S/D No.: 86-11 Name: LAMPLIGHTER MOBILE HOME PARK ADDITION

STAFF COMMENTS:

SUBDIVISION REPORT

S/D 86-11 - LAMPLIGHTER MOBILE HOME PARK ADDITION

Sketch Submitted with letter of credit

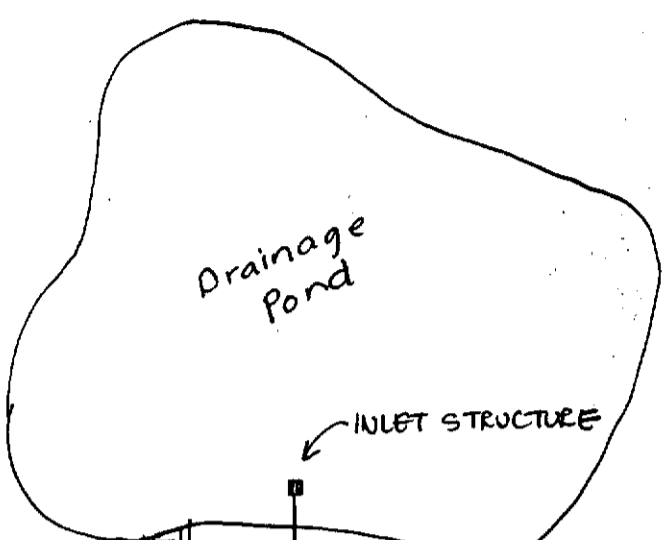
- G. The representative from the City Engineer's office should be prepared to comment on the status of the applicant's drainage plan.
- H. A requirement of preliminary plat approval was the submitting of a plan depicting the pavement geometrics for this mobile home park's driveway to MacArthur Road. This plan was to be submitted to the Traffic Engineer so a determination can be made as to the maximum width allowed for the park's entrance. The Traffic Engineer should be prepared to comment on the status of the plan.
